CITY OF ALBUQUERQUE

**Re: WAQ1 Delivery Station
7300 Meridian PI NW
Traffic Impact Study
Dated October 2020 (HT#J1D002G1)**

TRAFFIC IMPACT STUDY

WAQ1 Delivery Station
7300 Meridian Pl NW
Albuquerque, NM

Driveway (access) Locations

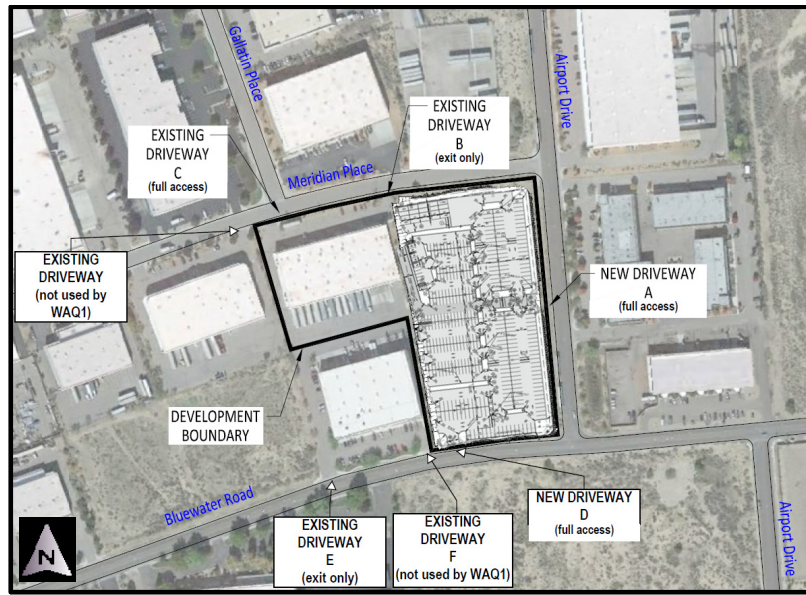
1. Driveway D will need to be designed further east to maintain a required 100 foot spacing from existing Driveway F while also maintaining 100 foot spacing from the Airport Drive/Bluewater intersection.
2. Design and construction of the proposed WAQ1 Delivery Station shall maintain adequate sight distances at proposed driveways.

Access Design Specifications

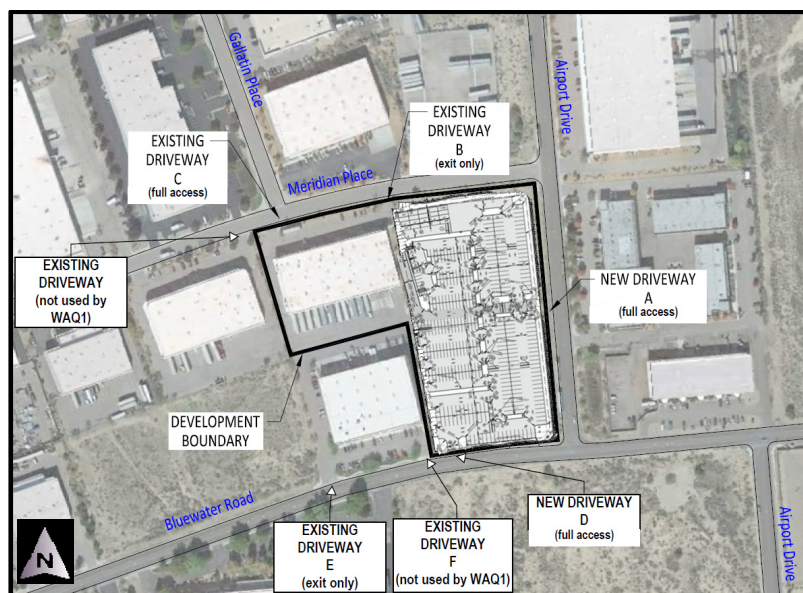
Proposed Driveway D is a full access driveway and is located about 75 feet from existing Driveway F to the west of its proposed location. It is recommended that Driveway D be relocated further east to maintain the DPM's 100 foot spacing between adjacent driveways requirements, while maintaining a required spacing of 100 feet from the Airport Dr. intersection.

1. Driveway D will need to be designed further east to maintain a required 100 foot spacing from existing Driveway F while also maintaining 100 foot spacing from the Airport Drive/Bluewater intersection.
2. Design and construction of the proposed WAQ1 Delivery Station shall maintain adequate sight distances at proposed driveways.
